Judul artikel : Airflow-enhanced evaporation–condensation seawater desalination using residential air conditioner waste heat

Jurnal : Environ Progress and Sustainable Energy. 2026; e70555.
doi:10.1002/ep.70555

Major revision requested: 9984576

**3. Bukti Konfirmasi Submit Revisi Pertama,
Respon kepada Reviewer,
dan Artikel yang Diresubmit
(30 Mei 2026)**

Fig. 5. Evaporation results for each channel cross-sectional area (a) and comparison of the experimental and simulation results (b)

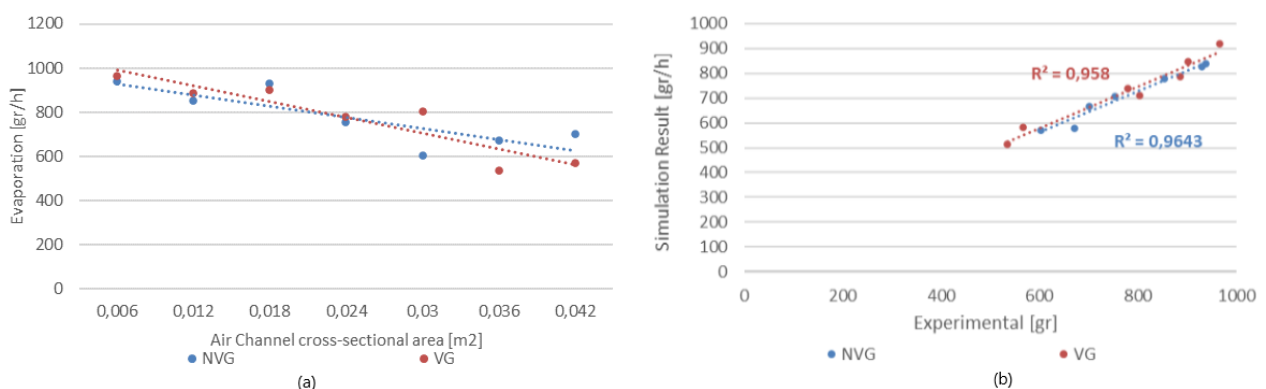
9. *The authors must conduct a statistical analysis thorough model validation to ensure the model accuracy with respect to freshwater production and waste heat recovery.*

We thank the reviewer for this important comment. Additional model validation and statistical comparison discussions have been incorporated into the revised manuscript to strengthen the reliability of the numerical model in predicting freshwater production and thermal performance. The CFD predictions were validated against experimental measurements under different channel cross-sectional areas and vortex-generator configurations. Statistical agreement between the numerical and experimental results was evaluated using the coefficient of determination (R^2) and average deviation analysis.

The comparison demonstrated strong linear correlations between CFD predictions and experimental measurements, with coefficients of determination exceeding $R^2 > 0.95$ for both NVG and VG configurations. In addition, the average deviations between numerical and experimental results were approximately 6–10%, remaining within the commonly accepted validation range for thermal–fluid studies. The revised manuscript also includes additional discussion regarding the relationships among airflow characteristics, evaporation enhancement, pressure drop, and AC coefficient of performance (COP) under different channel geometries. These analyses confirm that the numerical model provides sufficiently accurate prediction of evaporation behaviour and AC operational response under the investigated operating conditions.

Fig. 6. COP of Split model AC compare with evaporation for each cross-sectional area

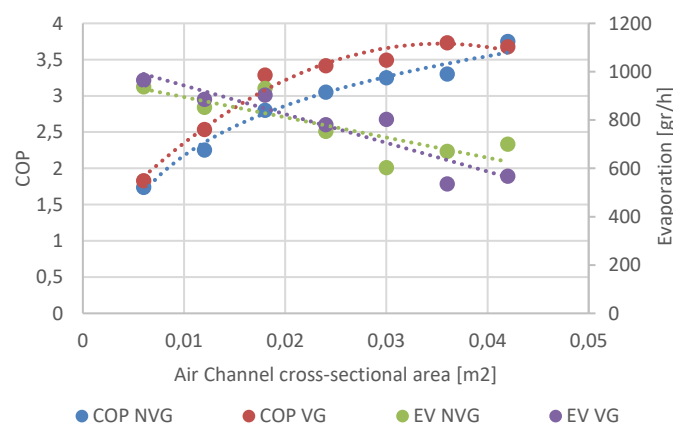
Is the AC condenser fan able to maintain required airflow when the channel area is very small (e.g., 0.006 m²)? Did the fan operate at reduced flow or stall? Was fan power or current monitored?

Effectively demonstrates the correlation between air channel cross-sectional area and evaporation rates. The use of vortex generators is shown to enhance local turbulence and disrupt the boundary layer, which is scientifically sound. The linear correlation ($R^2 > 0.95$) between CFD and experimental data is excellent. However, the discussion on the trade-off between evaporation and AC performance (COP) is present but needs a more critical comparison. Thus, it is suggested to provide a direct comparative table or graph showing the "Percentage Loss in COP" versus "Freshwater Yield" for each channel size. This would help practitioners understand the exact efficiency cost of maximizing water production.

We sincerely thank the reviewer for the constructive suggestion. The revised manuscript has been expanded to more clearly discuss the trade-off between freshwater production and AC operational performance under different channel geometries on page 14. As suggested, additional comparative discussion was incorporated to highlight the relationship between freshwater yield and the corresponding COP reduction at different channel cross-sectional areas.

The revised discussion now more explicitly explains this airflow-driven trade-off and clarifies that the optimal operating condition was achieved at channel cross-sectional areas of 0.015–0.025 m², which provided high freshwater production rates (approximately 950–980 mL/h) while maintaining acceptable AC operational performance. This additional analysis was included to improve the engineering interpretation and practical applicability of the proposed desalination system for future HVAC-integrated freshwater production applications.

Since the residential split-type AC operated as a factory-integrated commercial system, the condenser fan current and standalone fan power were not monitored separately, AC operational performance was evaluated using the COP, calculated from Equations (1)–(5). Conventional residential AC systems generally exhibit COP values between 3.02 and 4.04^{54,55}, while the baseline COP of the AC unit used in this study was 3.92. After integration with the desalination unit, smaller channel areas produced higher pressure losses, restricting condenser airflow and reducing heat rejection effectiveness, thereby lowering COP. Nevertheless, the condenser fan remained operational throughout the experiments without observable flow interruption or stall conditions.

As shown in Fig. 6, COP increased progressively with increasing channel cross-sectional area because larger channels reduced airflow resistance and pressure drop. However, evaporation and
